09-AFC-4

RE: REVIEW AND APPROVAL OF THE LANDSCAPE PLAN AND SCREEN TREE PLAN FOR THE OAKLEY GENERATING STATION PROJECT

FIGURE 5.13-9
 LANDSCAPE PLAN
 CONTRA COSTA GENERATING STATION
 OAKLEY, CALIFORNIA

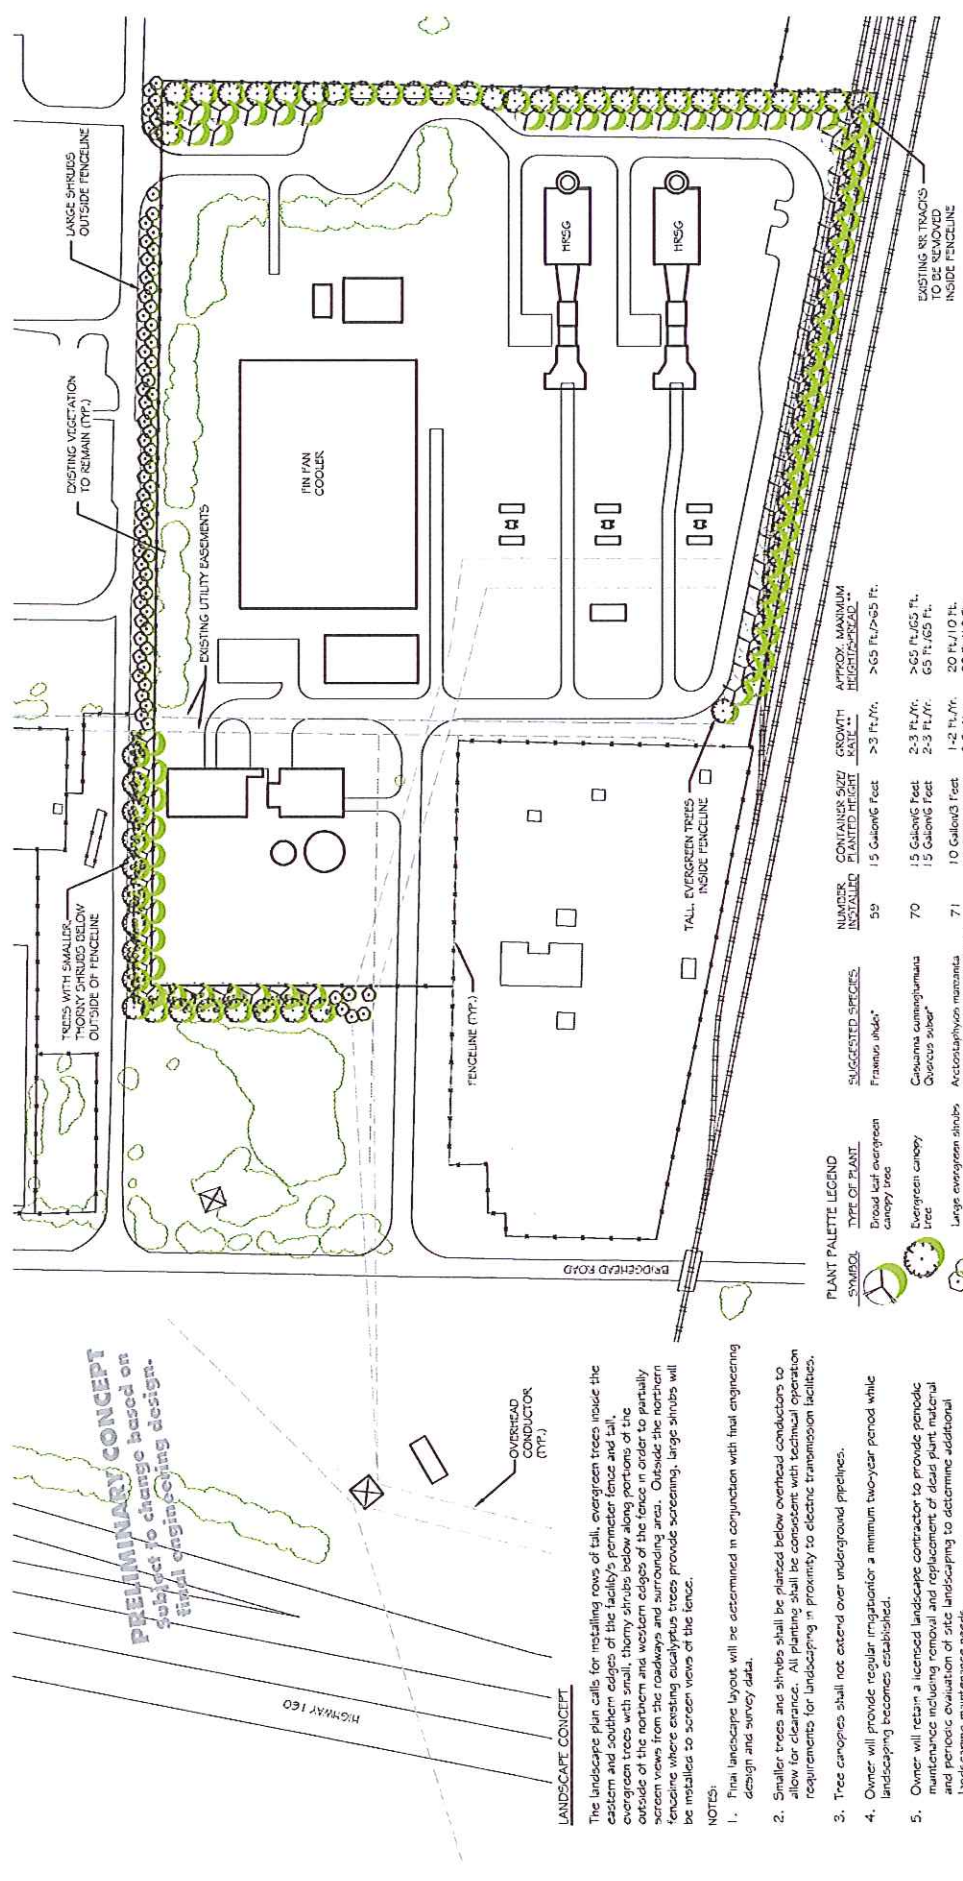
The Zoning Administrator for the City of Oakley has reviewed and approved the Landscape Plan and Screen Tree Plan for the Oakley Generating Station Project. The Landscape Plan includes the use of primarily native California drought tolerant plants and rows of tall, evergreen trees with shrubs below along portion of the outside of the northern and western edges of the property. Existing eucalyptus trees along the northern boundary provide screening, and additional shrubs will be installed. The approved plans are attached for reference, and are also shown as Figure 5.13-9 Landscape Plan, submitted to the CEC for the Oakley Generating Station Project.

1. A detailed irrigation plan and water efficient landscape package as part of the plan check process. The plan shall be prepared by a licensed landscape architect and shall be certified to be in compliance with the City's Water Efficient Landscape Ordinance.
2. Landscaping shall conform to the City's Water Efficient Landscape Ordinance and shall be installed prior to final occupancy.
